Dear Editor and Reviewers,

Reply to Anonymous Referee #1

Reply to D. Shugar

Fig. R1) Visual interpretation of potential debris-supply slopes on a PRISM image. (1) Traces or scars show the possibility of debris supply. (2) Small hills identified by shadings and (3) depressions outside lateral moraine may prevent debris supply.

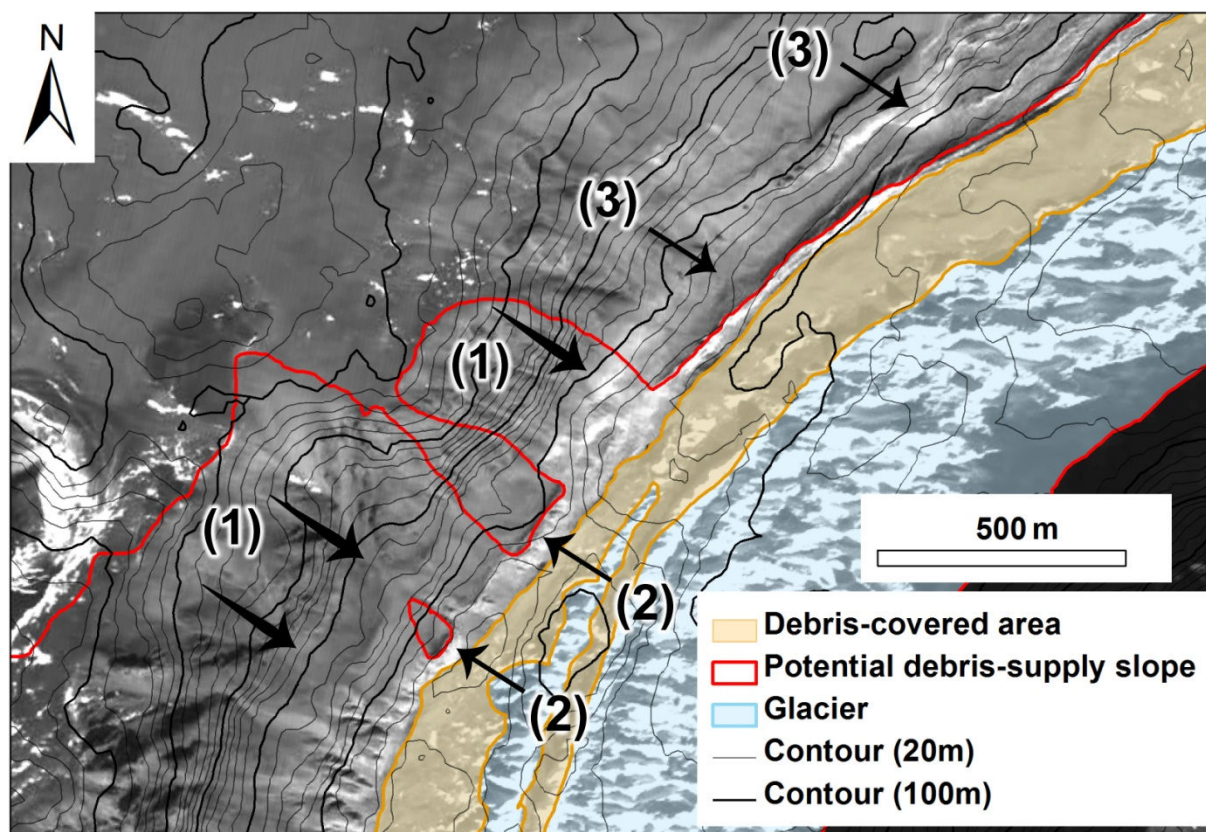
P1677 L25 – It is unclear what is meant by “...delineation error was modified.” Please clarify. Further, it is unclear why the authors overlaid the 2.5-m PRISM- and 10-m AVNIR-derived glacier outlines onto Google Earth imagery. Is the Google Earth data higher resolution?

P1678 L1 – I don't understand what “topographic contour lines” used to delineate glacier outlines are. Do the authors mean they looked at the inflection point in the lateral slopes?

P1679 L19 – The description of the potential Debris supply slopes is somewhat confusing. A figure might help to clarify.

Response: We will add a new figure (attached below) and revise the description of glacier delineation (Chapter 2.3, P1679) as:

We define potential debris-supply (PDS) slopes that could supply the debris mantle. Such slopes were manually extracted as the continuous slope between the glacier margin and mountain ridges, downward to the glacier, using contour lines at a 20-m interval and a slope map derived from ASTER GDEM-2 (Fig. R1). More precise interpretation is given by the PRISM images. Rockfall- or avalanche-induced scars and traces are identified as rockfall possibility (Fig. R1). Slopes intercepted by hills or lateral moraines were excluded from the PDS slopes because rockfall would be prevented. Slopes with ephemeral snow cover were included to account for debris-supply induced by snow avalanches (e.g. Scherler et al., 2011b). Lateral and terminal moraines, which consist of allochthonous glacially transported sediment, were also included because we had no reliable threshold to separate them. Their area is, however, expected to be quite smaller than that of the headwalls which is the dominant part of PDS slopes.
